PARKLAND HIGH SCHOOL EXPANSION

SKETCH PLAN 2024-103

SUBJECT: Parkland High School Expansion
Sketch Plan 2024-103
SKETCH PLAN REVIEW

SUBJECT: South Whitehall Township
Parkland High School Expansion
Major Plan #2024-103
Sketch Plan Review

SEAL:
SK-1 SKETCH PLAN

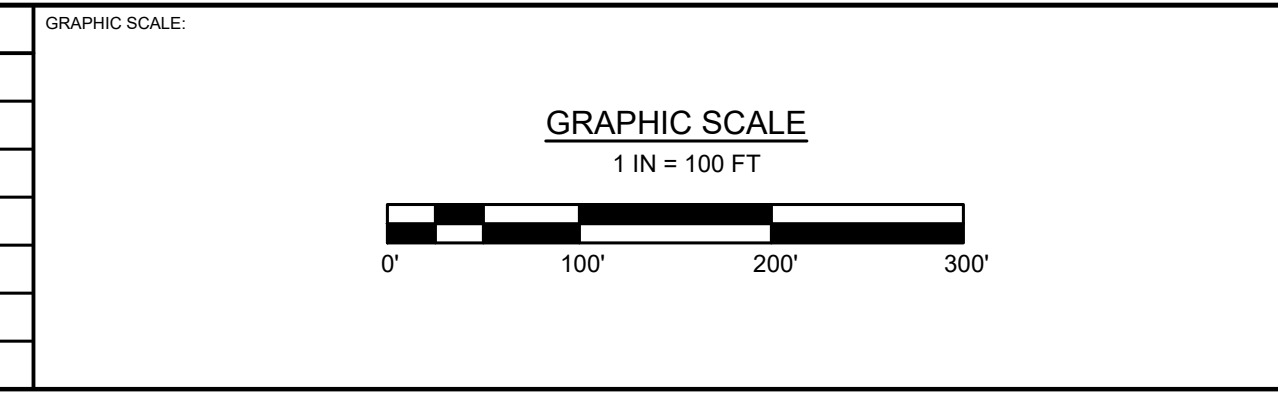
1. The project is located in the Jordan Creek Watershed Act 167 Subareas 125 and 126 which are provisional no detention release rate districts. General Stormwater BMP locations have been proposed on the Plan. Stormwater management system plans and design calculations which demonstrate that the proposed development will meet the Act 167 requirements and the water quality volume (WQv) requirements for discharge to any contiguous properties for each discharge point should be submitted for review with the Preliminary Plan;

2. The following improvements along the property frontage are required along Cedar Crest Boulevard, Ritter Road, and Orefield Road: right-of-way dedication, cartway widening, curb, sidewalk, monuments, shade trees, etc. (SALDO §312-26(a) §312-35(b), §312-36, and §312-40 pertain), and should be shown on the Plans. Any improvements along Cedar Crest Boulevard and Orefield Road are to be reviewed and permitted by PennDOT;

3. Confirm with PennDOT, the continued acceptability of the driveways along Orefield Road and Cedar Crest Boulevard based on the increased traffic;
4. Due to the expected increase in traffic, the School District should consider investigating the signal at the Cedar Crest Boulevard driveway to optimize operations for traffic during the various peak hours of the school, (AM drop-off, PM drop-off, after school activities, sporting events, etc.);

5. The proposed parking lot provides very little separation between its southern edge and the campus driveway. Consideration should be given for potential future widening or the extension of the campus' existing path;

6. Address the following Sketch Plan related comments:
 - a. List the Zoning District within the subject property in the Narrative, SALDO §312-10(a)(5);

- b. Provide Plans to LANTA and United States Postal Service, SALDO §312-10(a)(6) and §312-10(a)(7);
 - c. Dimension the front, side, and rear yard setbacks and proposed right-of-way, SALDO §312-10(b)(9);

- d. Provide property boundary information within the site and within 200 feet of the site, SALDO §312-10(b)(10). We note that the Plan does not show the entire lot line;

- e. Show any proposed staging, SALDO §312-10(b)(11);
 - f. Identify significant physical and topographical features including the floodplain and its basis, wetlands, water conservation areas, steep slopes, and woodlands, or note the absence of such, SALDO §312-10(b)(12); and

- g. Label and dimension the Cedar Crest Boulevard, Ritter Road, and Orefield Road cartway widths and rights-of-way, SALDO §312-10(b)(14).
7. Address any concerns of the Public Safety Commission. We have not reviewed and would defer to the Township Fire Marshal and emergency response personnel regarding the acceptability of emergency access, the requirements for fire protection systems, etc.;

8. Address any concerns of the Landscape and Shade Tree Commission, specifically as it relates to any tree protection areas, buffering, etc.;
 9. The Township should determine whether open space, or fees in lieu of, will be required, and an appropriate note should be placed on a Preliminary Plan, SALDO §312-34(d); and

10. Address any concerns of the Department of Public Works regarding the water services SALDO §312-10(b)(5)(D).
